Conway Planning Commission Staff Report

7:00pm • July 16, 2018 • 810 Parkway Avenue

CONWAY CITY PLANNING DEPARTMENT REVIEW STATION HAUS ADDITION PRELIMINARY PLAT

CONWAY CITY PLANNING DEPARTMENT REVIEW FREYALDENHOVEN SUBDIVISION PRELIMINARY PLAT

Proposed Preliminary Plat

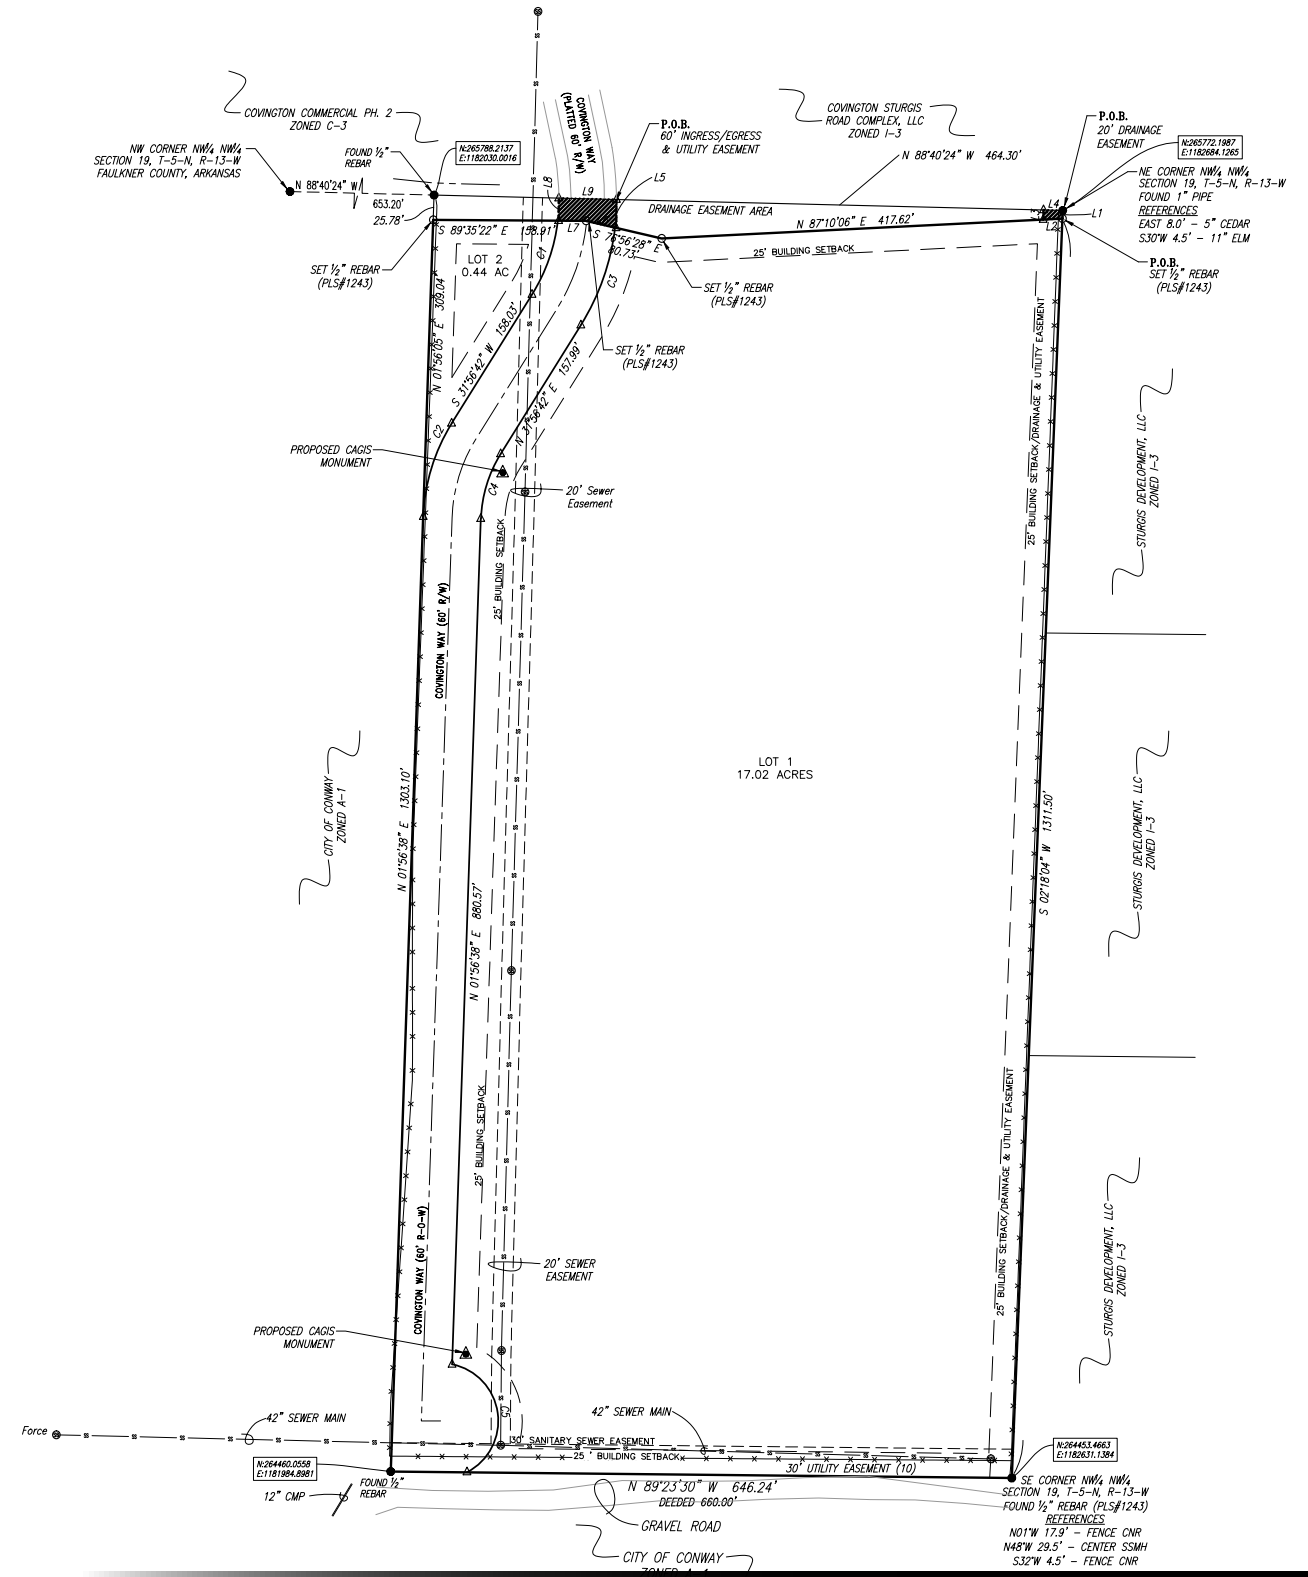
1. The name of the subdivision/replat is needed. Change name from Apartment to Addition
2. The layout of all proposed sidewalk systems are needed, along with relevant dimensions and bearings.
3. Proposed easements are needed.
4. A phasing plan outlining the boundaries for each phase and the location of all CAGIS monuments for the subdivision is needed. A minimum of two CAGIS monuments shall be placed in each subdivision or subdivision phase exceeding ten (10) acres. For subdivisions of ten (10) acres or less in size, no new CAGIS monumentation is required. However, these smaller subdivisions must all be tied to CAGIS monumentation.
5. The Certificate of Preliminary Plat Approval is needed. Change signer to Jerry Rye, Planning Commission Chairman.

- 17. The Planning Commission may authorize a new boundary street when the subdivider agrees to dedicate the entire right-of-way and construct all the required improvements. **Planning Commission authorized this condition.**

- 18. State Fire Code 503.0.5 states that dead-end fire apparatus access roads in excess of 150 feet in length shall be provided with an approved area for turning around fire apparatus. Anything other than the following cul-de-sac requirement must be approved by the Conway Fire Marshall. All aspects of the Fire Department access on the south side will be completed per City of Conway regulations and agreements.

- 23. Blocks over 1000 feet in length may require a public crosswalk within a dedicated easement of not less than 15 feet in width including a paved crosswalk not less than five feet in width to provide pedestrian circulation. **Planning Commission approved this condition.**

STAFF RECOMMENDATION
Staff recommends the approval of the preliminary plat subject to the amended punch list.
